# V5\_Drainage letter\_comments.pdf Markup Summary

**FINAL DRAINAGE REPORT  
LOT 2, BENT GRASS EAST COMMERCIAL FILING NO. 4  
CARUBIA PROPERTIES**

PCD FILE NO. PPR256

JUNE 19, 2025

PROPOSED  
DRAINAGE PLAN

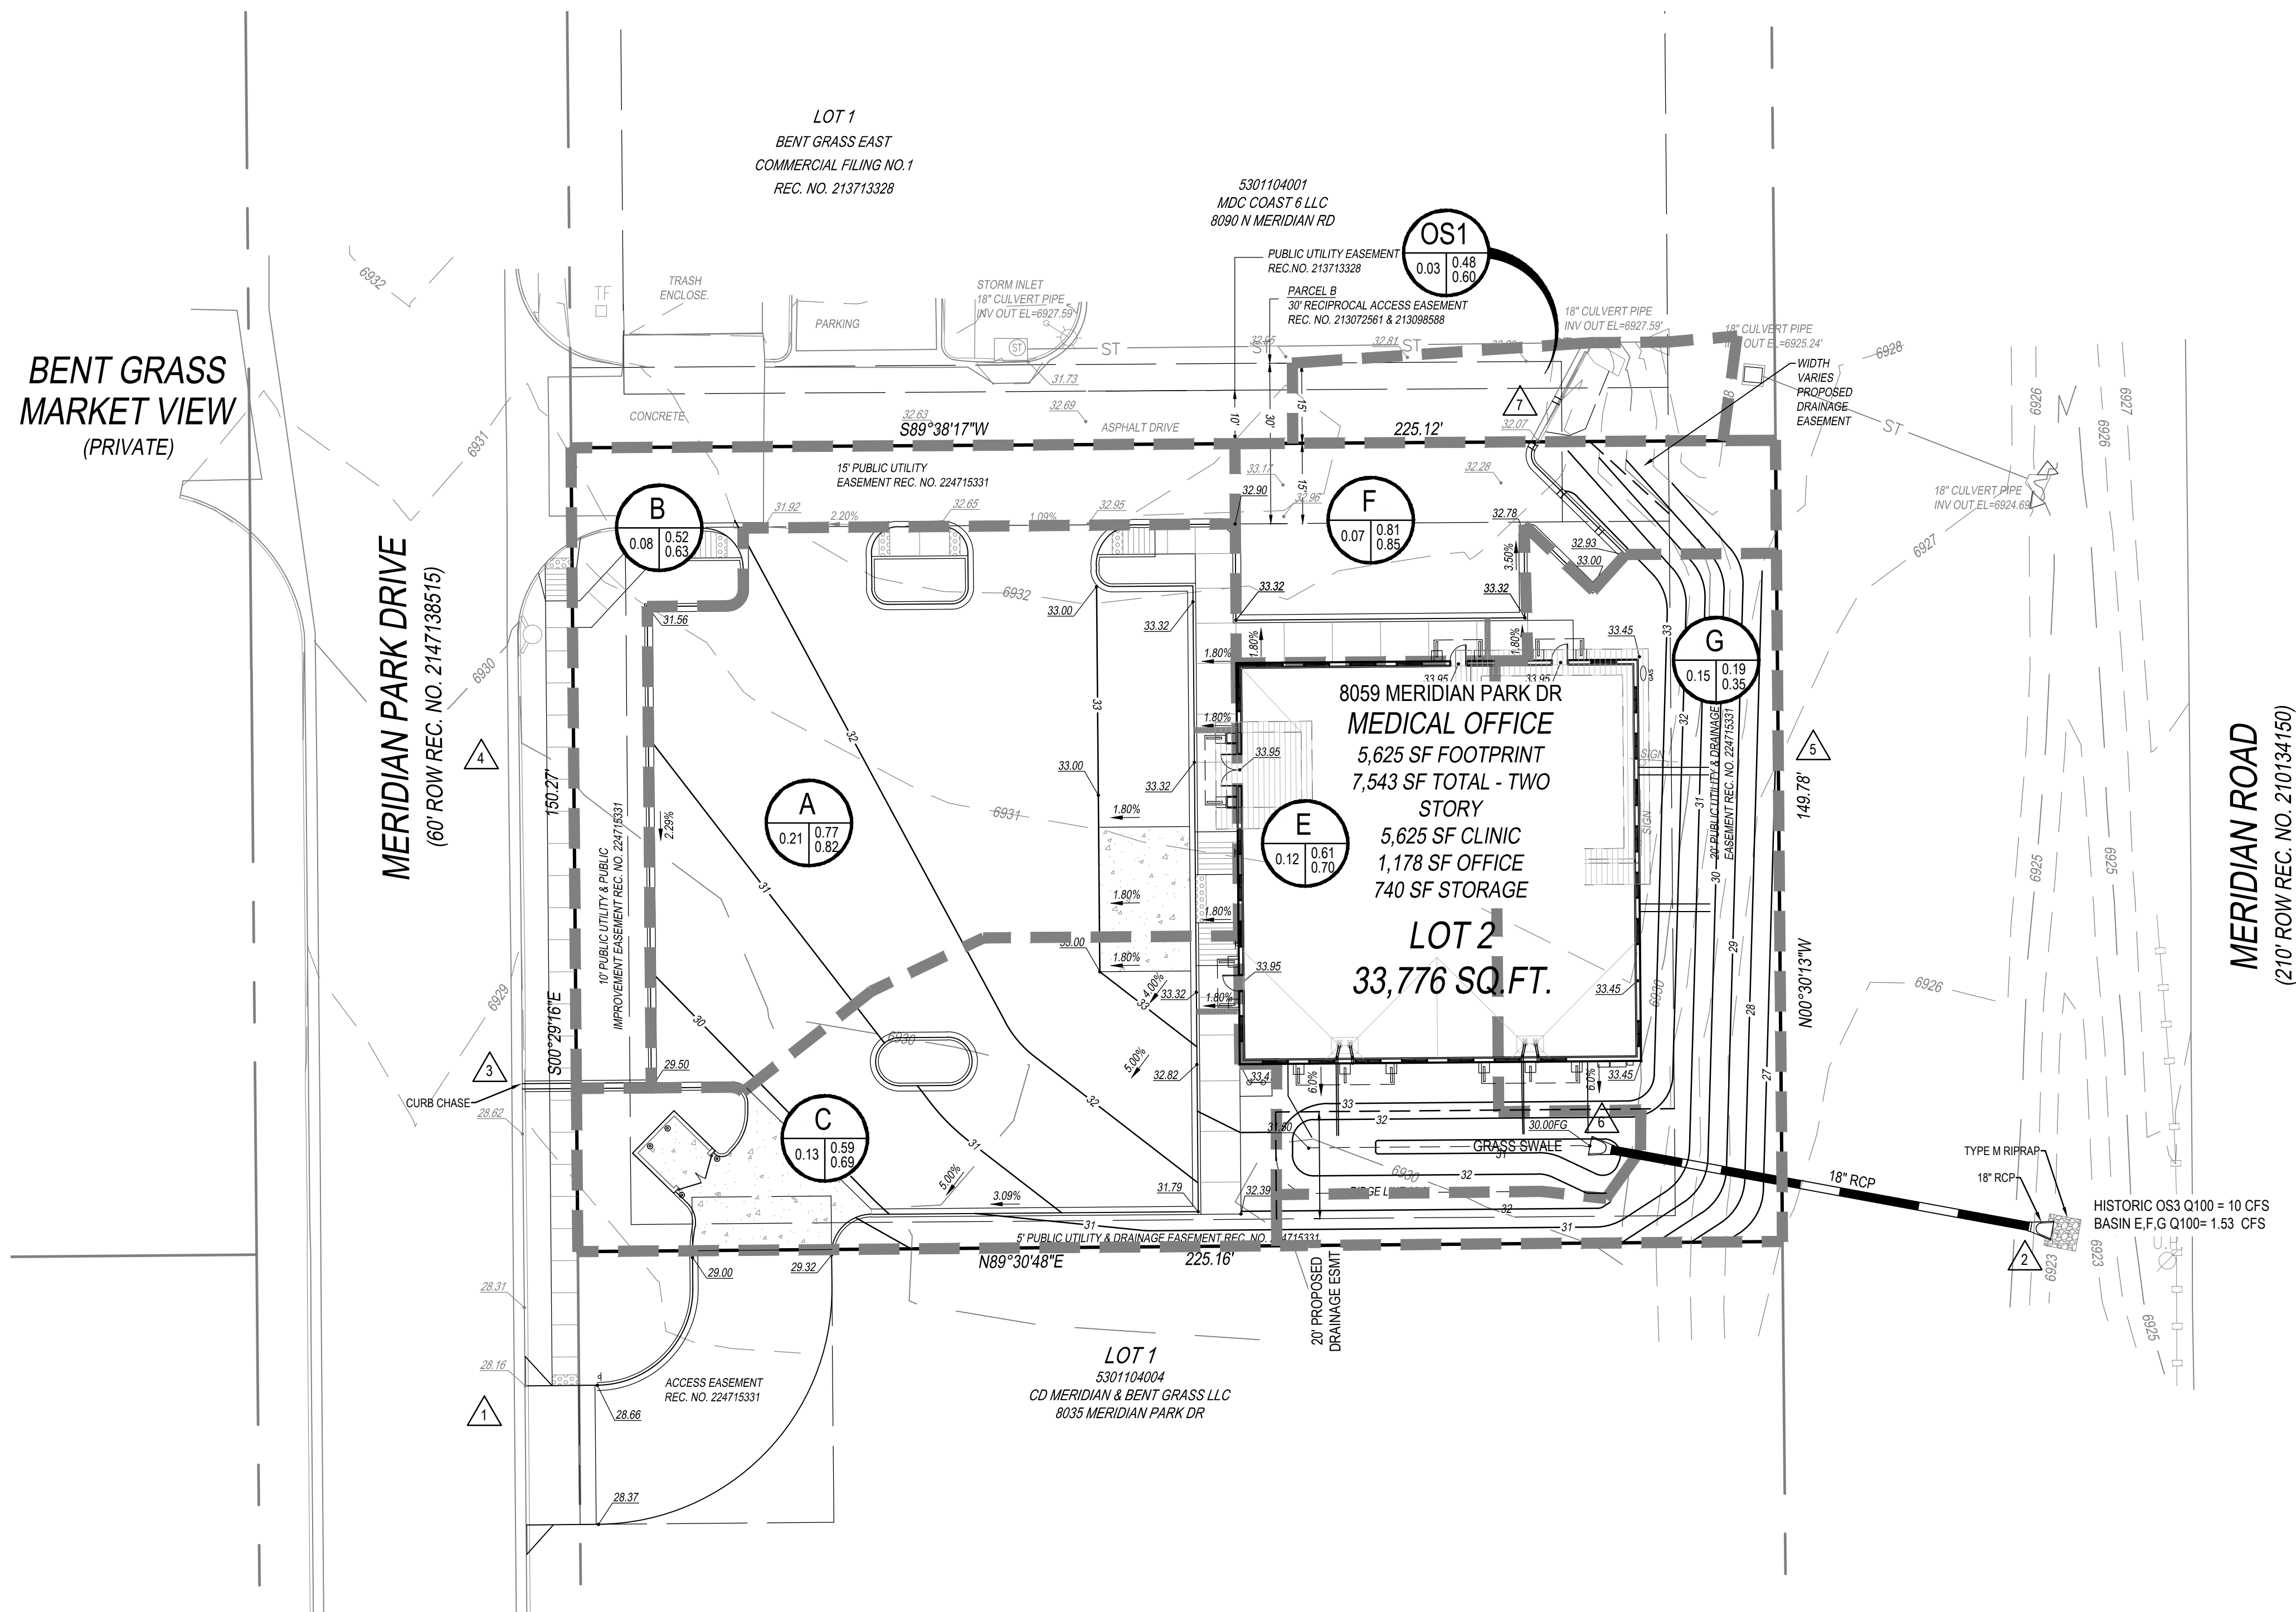
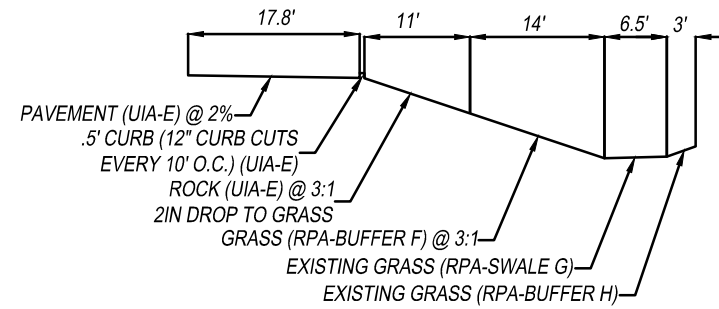
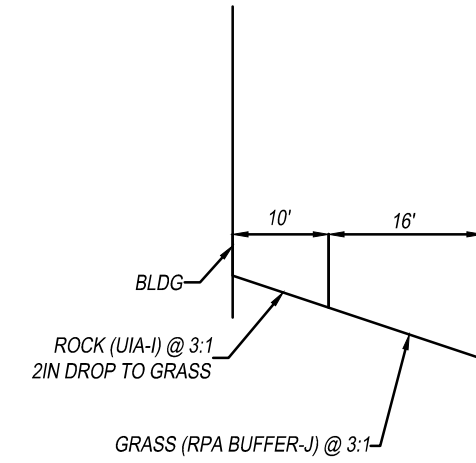
Please update this sheet per all of my comments in the duplicate sheet in the CDs.
